RHODE ISLAND DEPARTMENT OF TRANSPORTATION

Barrington Bridge - Underwater Repairs

NOTICE TO PROSPECTIVE BIDDERS

ADDENDUM NO. 3 Prospective bidders and all concerned are hereby notified of the following changes in the Plans, Specifications, Proposal and Distribution of Quantities for this contract. These changes shall be incorporated in the Plans, Specifications, Proposal and Distribution of Quantities, and shall become an integral part of the Contract Documents.

REVISIONS RHODE ISLAND NO. DATE BY DEPARTMENT OF TRANSPORTATION BRIDGE REHABILITATION BARRINGTON BRIDGE NO. 123 BARRINGTON RHODE ISLAND REPAIR **DETAILS II**

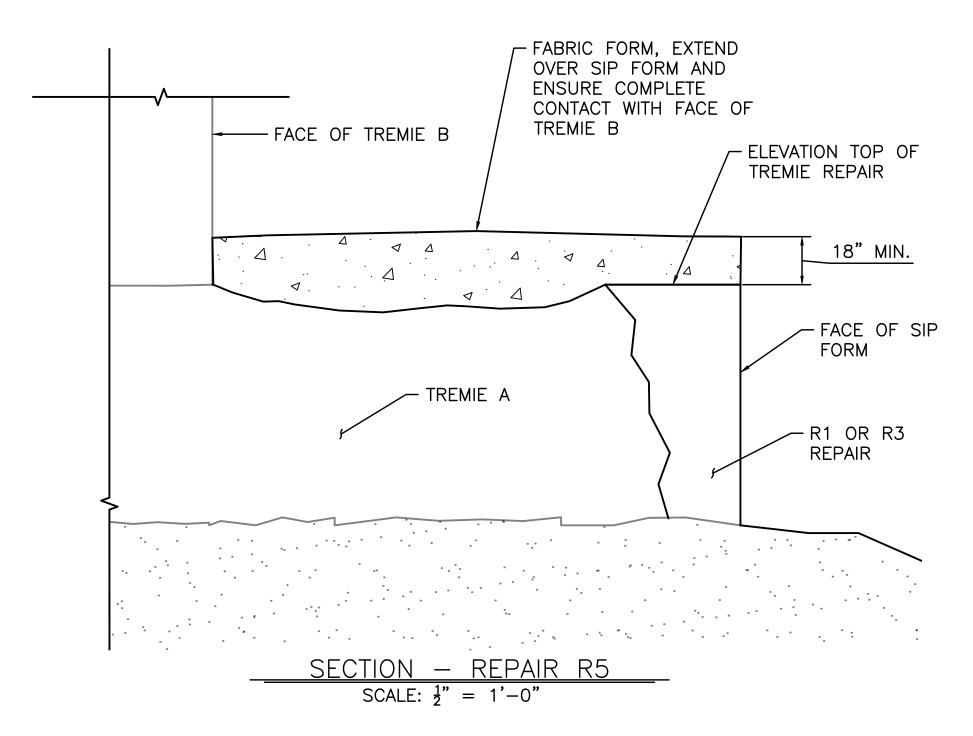
Delete Sheet No. 8 of 10 in its entirety and replace with Sheet No. 8 (R-1) attached to this Addendum 3. Added Note 6. to Repair R5 Notes that requires 6 feet minimum width of the flexible fabric forms.

- REPAIR TYPE 5 FOLLOWS REPAIRS 1-4 WITH PUMPED GROUT IN THE FABRIC FORMS.
- REMOVE MARINE GROWTH AND DEBRIS FROM THE TOP OF TREMIE A.
- PROVIDE FLEXIBLE FORMS SIZED AND ALIGNED IN GENERAL ACCORDANCE WITH THE PLAN. MINIMIZE THE NUMBER OF FORMS USED AND SUBSEQUENT JOINTS BETWEEN THE FORMS.
- 4. ALIGN AND SIZE FORMS INSTALLED NORTH AND SOUTH OF THE PIER STEM TO MINIMIZE JOINTS PARALLEL TO THE PIER'S LONGITUDINAL AXIS AND ALIGN AND SIZE FORMS INSTALLED EAST AND WEST OF THE PIER STEM TO MINIMIZE JOINTS PERPENDICULAR TO THE PIER'S LONGITUDINAL AXIS.
- 5. FILL EACH FLEXIBLE FORM WITH PUMPED GROUT TO DEVELOP A MINIMUM 18 INCH FILL HEIGHT AND TO DEVELOP FULL CONTACT WITH TREMIE B AND ADJACENT FORMS.
